## CAMPAIGN FOR THE PROTECTION OF RURAL WALES

### **APPENDIX 1. Application of Constraints: Arup vs Aecom methodology**

**Map 1: Priority Areas mapped against Landmap Visual and Sensory High (orange) and Outstanding (red)**

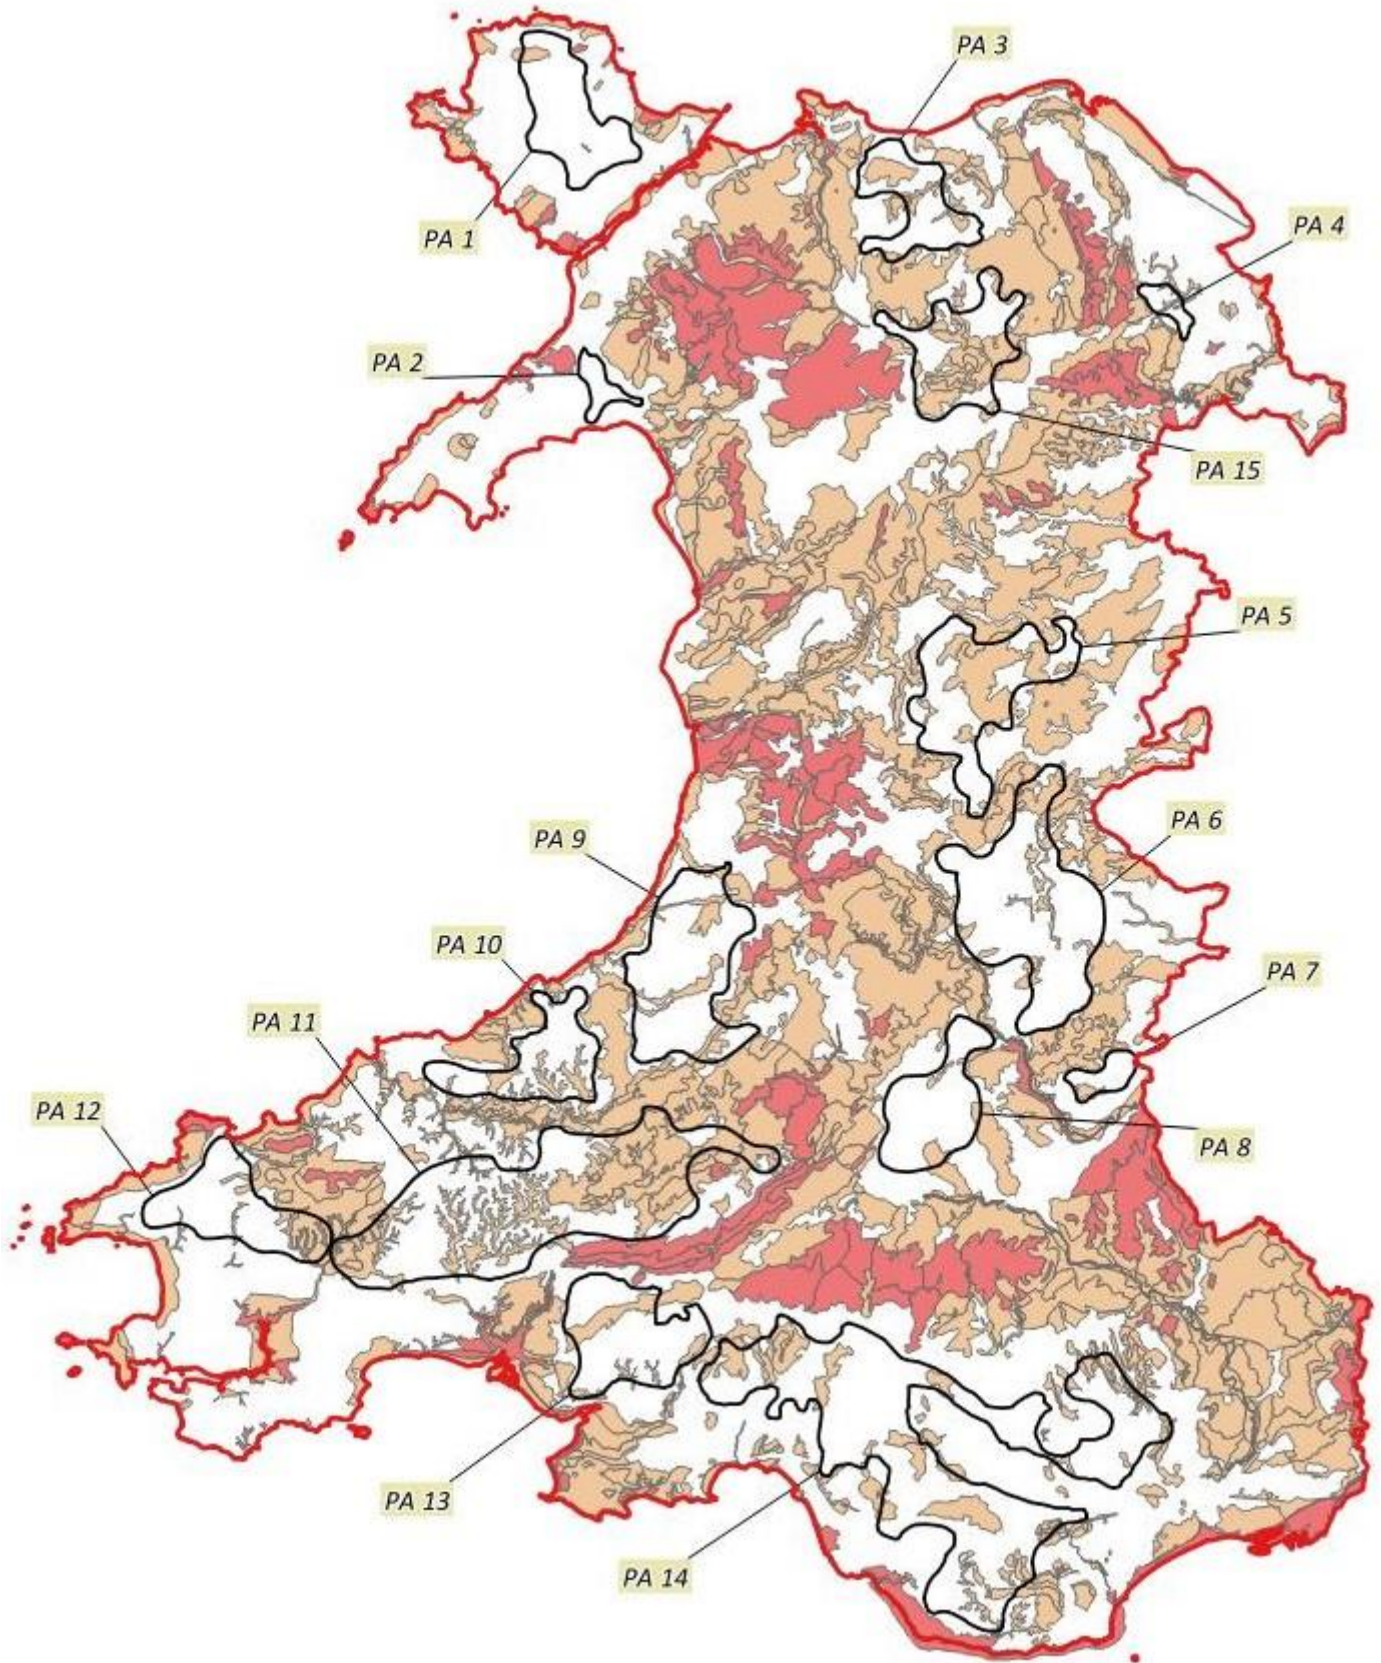
| AECOM STEPS   | AECOM TOOLKIT <sup>1</sup> WIND (POWYS LDP REA 2017)   | AECOM TOOLKIT <sup>1</sup> SOLAR (POWYS LDP REA 2017)  | ARUP fixed/variable constraints applied to identify unrefined Priority Areas - according to Tables 2 & 3 pp10-11 ARUP 2 <sup>1</sup> - BUT see NOTES:                      | NOTES ON ARUP METHODOLOGY  |
|---|--|--|--|--|
|   |  |  | <b>Landmap V&amp;S layer high and outstanding (variable) – both</b>  | <b>Landmap V&amp;S High has <u>not</u> been excluded. Only PA 2 does <b>NOT</b> contain Landmap V&amp;S High landscapes. Policy 10 <b>removes</b> landscape protection. <b>SEE MAP 1 BELOW.</b></b>  |
